Office Action Summary

10/797,839

BLAKE ET AL.

DETAILED ACTION

FIG. 4

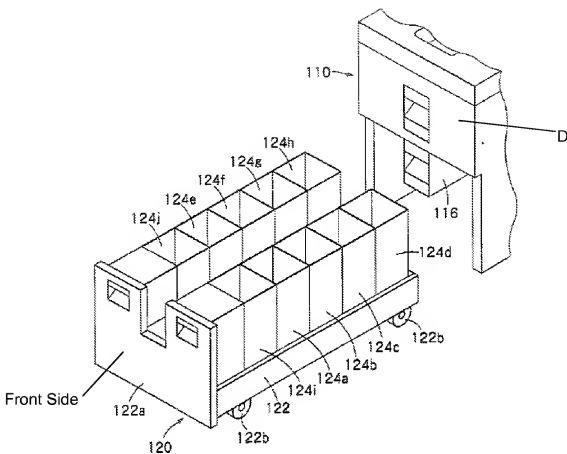
Claim 15: rear side (See FIG. 4 below, D); housing (See FIG. 2, 110);

Claim 16: front side (See FIG. 4 below, D; Note: the location of D can be defined as the rear or front side); housing (See FIG. 2, 110);

Claim 15: rear side (See FIG. 4 below, D); housing (See FIG. 2, 110);

Claim 16: front side (See FIG. 4 below, D; Note: the location of D can be defined as the rear or front side); housing (See FIG. 2, 110);

FIG. G1

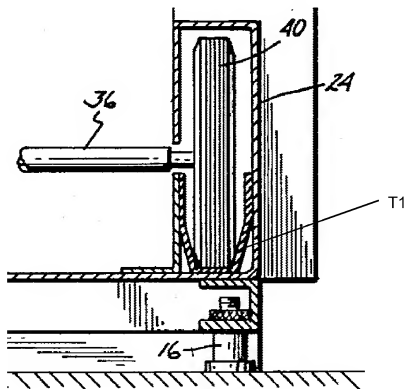
Muellner shows a similar device having a track (see FIG. G1 below, T1) for the purpose of receiving and capturing the casters (column 2, lines 57-66). Therefore, it would have been obvious to a person having ordinary skill in the art at the time the invention was made to modify Hino as taught by Muellner and include Muellner's similar device having a track for the purpose of receiving and capturing the casters.

Muellner shows a similar device having a track (see FIG. G1 below, T1) for the purpose of receiving and capturing the casters (column 2, lines 57-66). Therefore, it would have been obvious to a person having ordinary skill in the art at the time the invention was made to modify Hino as taught by Muellner and include Muellner's similar device having a track for the purpose of receiving and capturing the casters.

Muellner shows a similar device having a track (T1 above) for the purpose of receiving and capturing the casters (column 2, lines 57-66). Therefore, it would have been obvious to a person having ordinary skill in the art at the time the invention was made to modify Hino as taught by Muellner and include Muellner's similar device having a track for the purpose of receiving and capturing the casters.

Muellner shows a similar device having a track (T1 above) for the purpose of receiving and capturing the casters (column 2, lines 57-66). Therefore, it would have been obvious to a person having ordinary skill in the art at the time the invention was made to modify Hino as taught by Muellner and include Muellner's similar device having a track for the purpose of receiving and capturing the casters.
